# CHABOT-LAS POSITAS COMMUNITY COLLEGE DISTRICT PURCHASING DEPARTMENT

## **Addendum No. 3 INVITATION TO BID.: B19/20-17 POOL RENOVATION PHASE II (REBID) CHABOT COLLEGE**

EXHIBIT 3.1

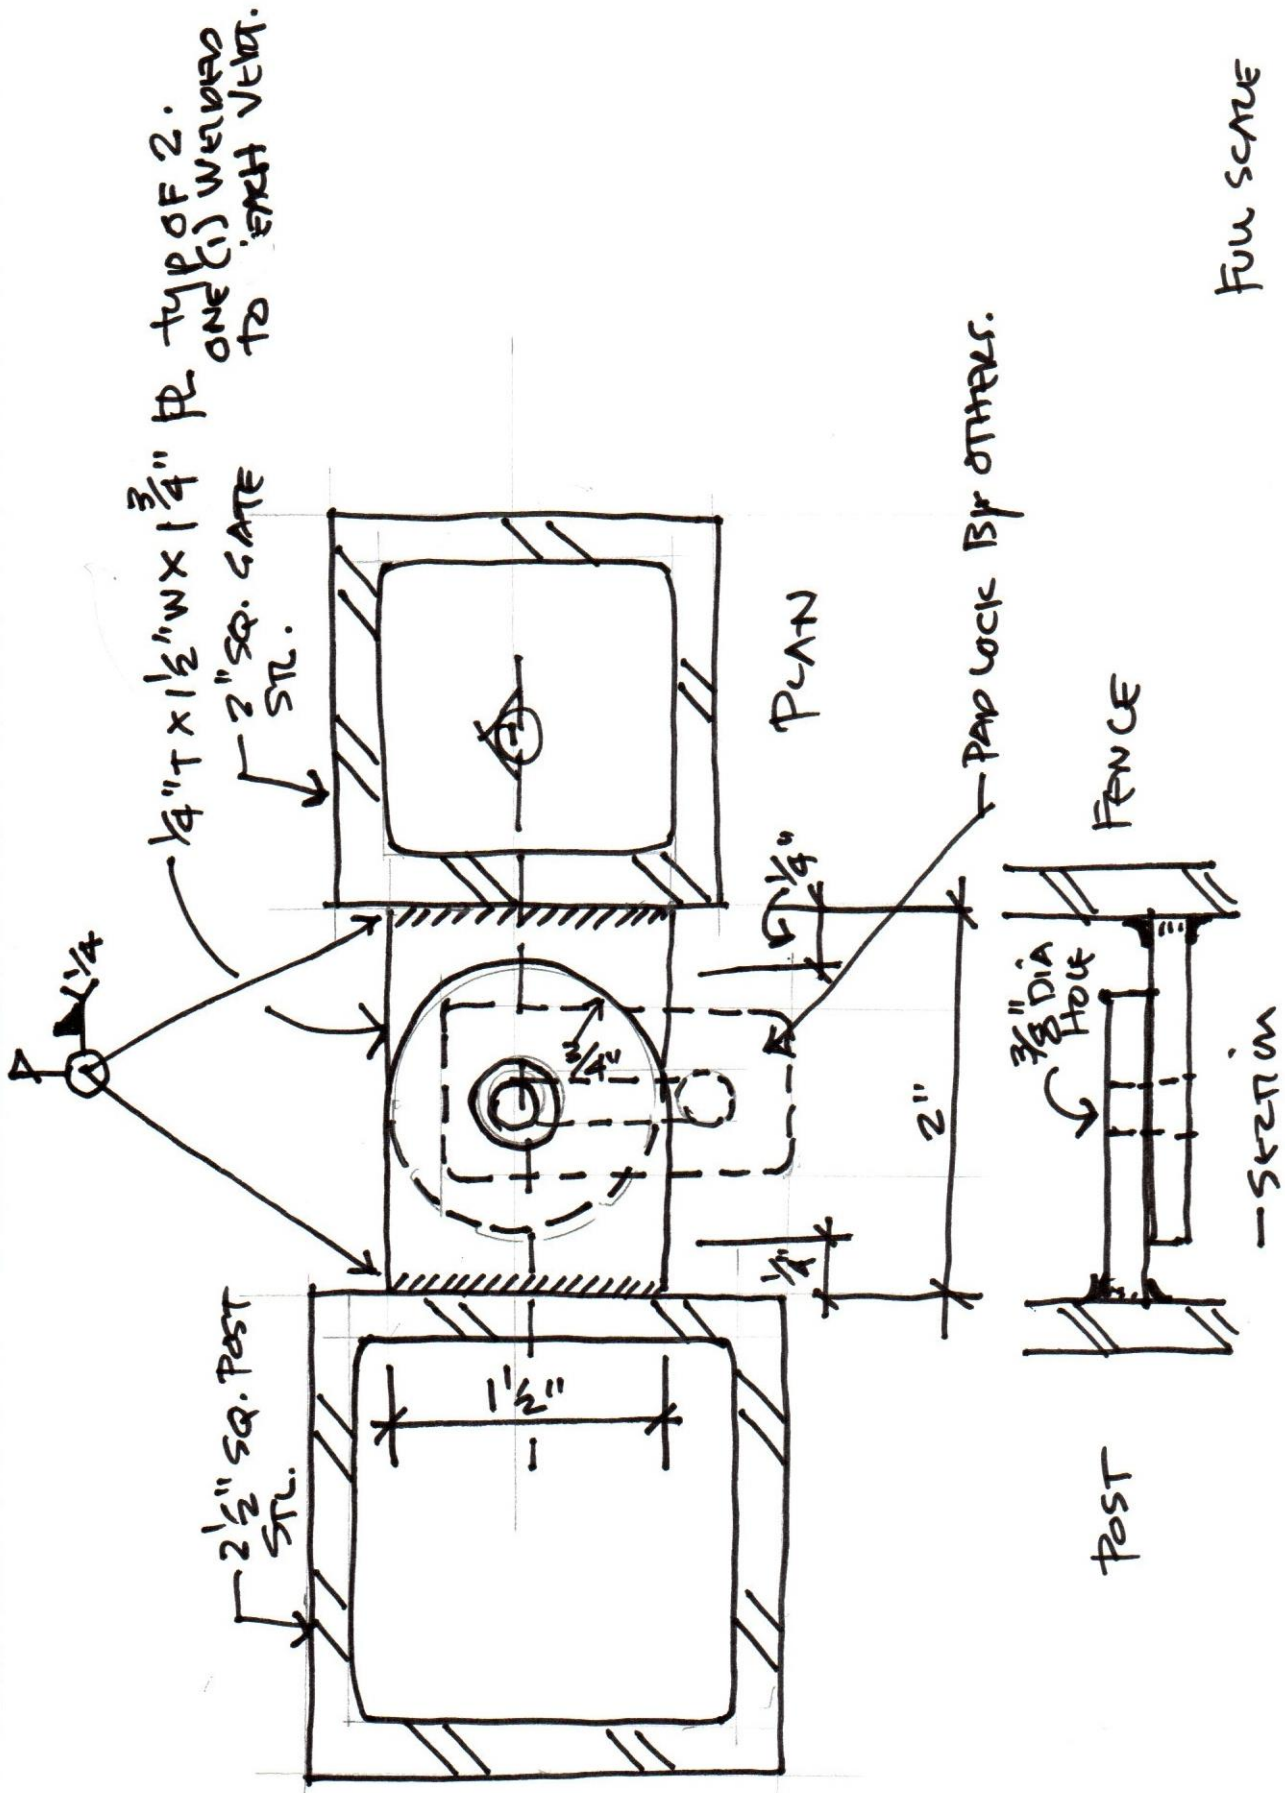
Question 3: How do you want the 8' swinging delivery gate and two bleacher gates to connect to gate posts (nonhinged side)? For example, do you want a fork latch or something else.

**Response: We want dual 1/4" steel plates that are overlapped with the ability to inset a padlock. One plate welded to the gate and the other to the fence post. See the attached sketch – Exhibit 3.1.**

## 5 POOL SIGNAGE

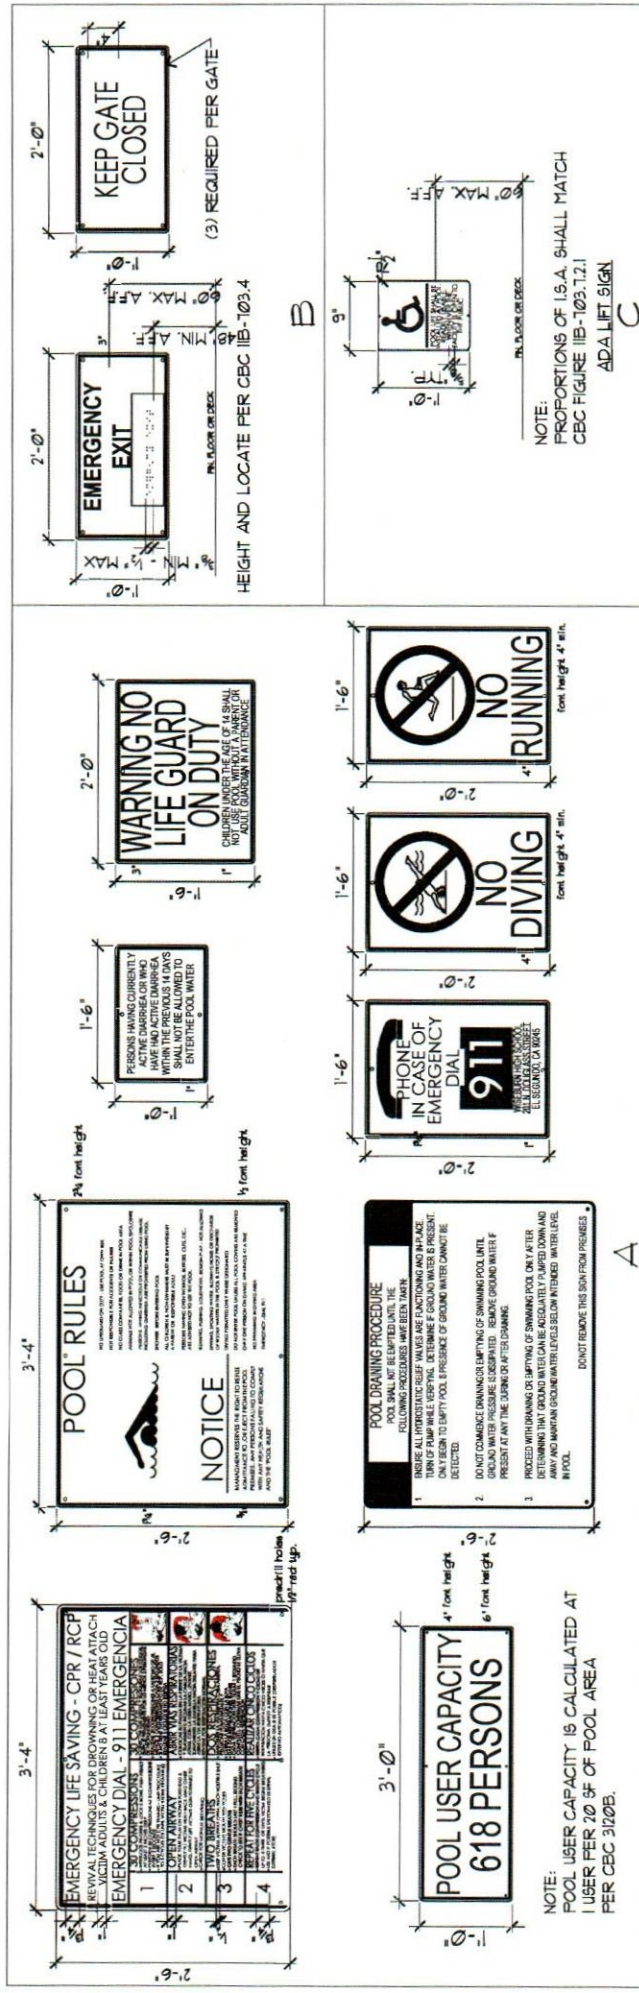
Question 4: Can you provide specs on signage? Are these to be reflective, aluminum, plastics, etc.

**Response: See Sheet SP9-2 for signage for gates and exiting. Detail 5, SP9-2, as well as other signage required. All gates will require the same signage, and the District will locate the remainder of the signs. Specification for signage, although part of the first phase is included herewith as Exhibit 3.2 attached, for this purpose of this work, the existing signage will be removed, and the new signs will be placed in their stead. Except for the ADA access, exiting, and gate information.**
